# Access Compliance Report

## Public Rights-of-Way

### (Curb Ramps)

Intersection ID: 9448	Main Street: DELTA LAKE DR	Cross Street: E W T HARRIS BV	Location: NE
ADA ID: 5D5F1D3D9740	Ramp Type: PerpDiag	Initial Pass/Fail: Fail	Overall Compliance: No
Codes/Mitigation Info/Possible Solution		Field Measurements/Component Compliance

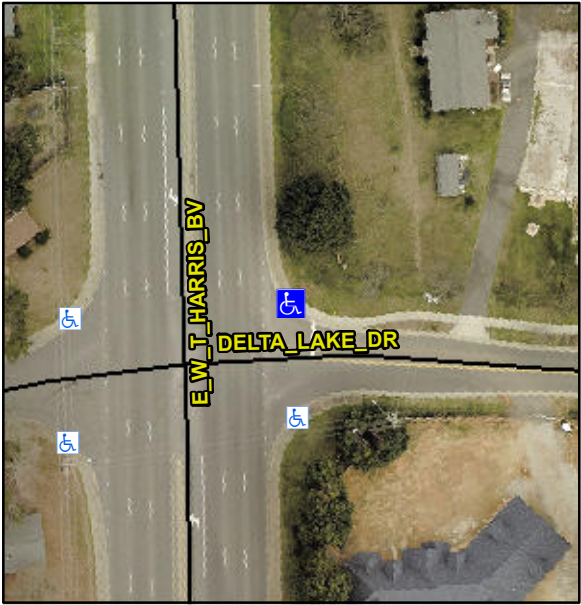
Possible Solutions:		Compliance		Description		Data	Compliance	Description	Data
	Remove & Replace Curb Ramp With Two New Directional Ramps or Equivalent.		N/A		Ramp Length (in)		61.0	No	Ramp Slope (%)	10.1
<p>Surveyor Notes:</p> <p>N/A</p> <p>PROW/ADA:</p> <p>Not Found, R304.2.2, R304.5.3</p>			Yes		Ramp Width (in)		48.0	No	Ramp XSlope (%)	2.9
			N/A		Flare Type LT		N/A	N/A	Flare Type RT	N/A
<p>Total Cost:</p> <p>\$ 3200.00</p>			N/A		Flare Slope LT (%)		N/A	N/A	Flare Slope RT (%)	N/A
			N/A		Flare Traversable LT?		N/A	N/A	Flare Traversable RT?	N/A
			N/A		Landing Length (in)		N/A	N/A	DWS Provided?	N/A
			N/A		Landing Width (in)		N/A	N/A	DWS Contrast?	N/A
			N/A		Landing Slope (%)		N/A	N/A	DWS Length (in)	N/A
			N/A		Landing X Slope (%)		N/A	N/A	DWS Full Width?	N/A
			N/A		Landing Curb? (Y/N)		N/A	N/A	DWS Offset (in)	N/A
			N/A		Shared Landing?		N/A			
			N/A		Gutter Ponding?		N/A	N/A	Gutter Slope (%)	N/A

N/A		Gutter Lip Ht (in)		N/A	N/A	Gutter X Slope (%)	N/A
			N/A		Painted X Walk1?		No	N/A	Painted X Walk2?	No
					X Walk 1 Direction		To W		X Walk 2 Direction	To S
			N/A		X Walk 1 Width (in)		N/A	N/A	X Walk 2 Width (in)	N/A
					X Walk 1 Slope (%)		1.9		X Walk 2 Slope (%)	2.6
					X Walk 1 X Slope (%)		2.0		X Walk 2 X Slope (%)	0.5
			N/A		Ramp inside XWalk1?		N/A	N/A	Ramp inside XWalk2?	N/A
					Road Slope (%)		1.4	N/A	Clear Space?	N/A
					Road X Slope (%)		1.1	N/A	Clear Space to XWalk (in)	N/A
			N/A		Any Obstructions?		N/A	N/A	Storm Grate/Utility Hazard?	N/A
					Obstruction Type				Storm Grate/Utility Type	
							N/A			N/A
								Yes	Surface Condition? (G/P)	Good
